ASI 38 - SIGNAGE

New Middle School
at
TORTOSA SOUTH

Maricopa Unified School District 20
Maricopa, Arizona

A0.1

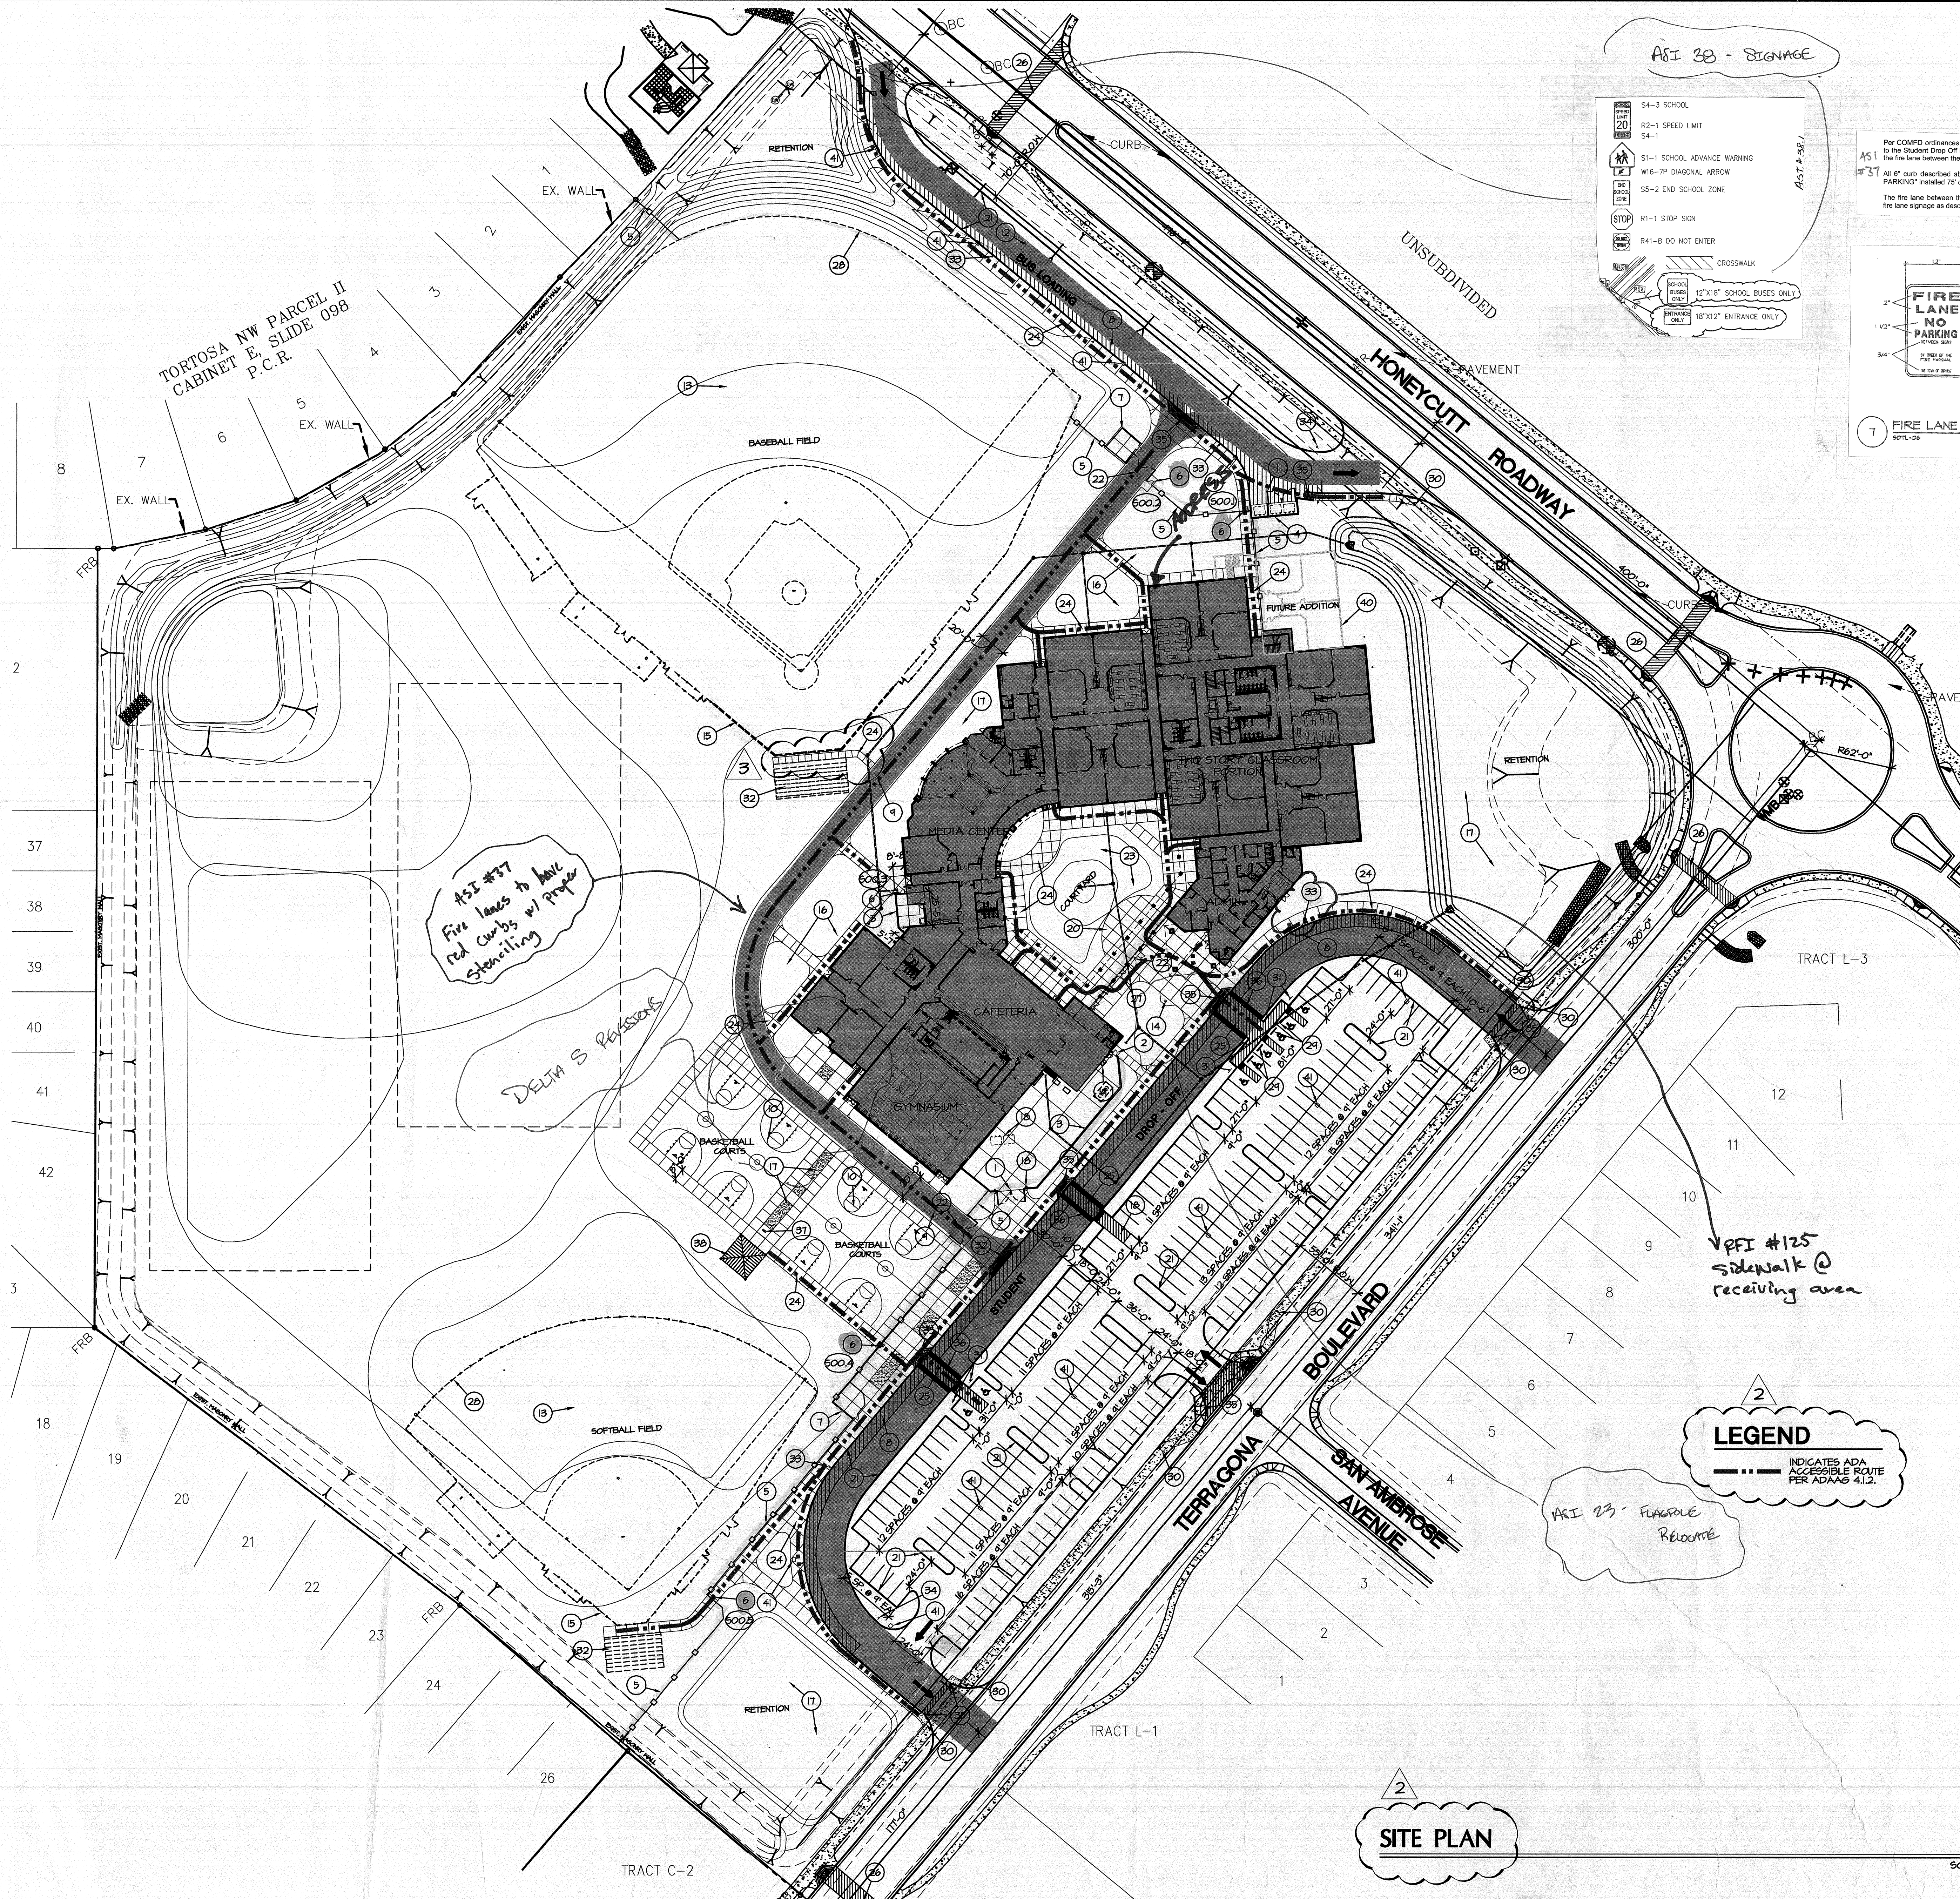
Per COMPD ordinance and instructions received from COM Fire Marshall, the 6" curb adjacent to the Student Drop Off Area and Bus Loop lane shall be painted red. The 12" flat curb bordering the fire lane between the buildings and the playground/basketball fields shall also be painted red.

ASI #37
At 6" curb described above shall receive in stenciled white letters the phrase "FIRE LANE NO PARKING" installed 75' on center.

The fire lane between the ballfields and the buildings shall also receive per COMPD ordinance the fire lane signage as described on the attached sketch installed 75' on center.

THE SIGNS SHALL BE MOUNTED ON A POST PER DETAIL 24. ON THE BOTTOM OF THE SIGN SHALL BE "NO PARKING" AND NO GREATER THAN 100' APART

SIGNS SHALL BE POSTED FACING NORMAL DIRECTION OF TRAVEL

SIGNS SHALL NOT BE SUPPLIED BY THE CITY
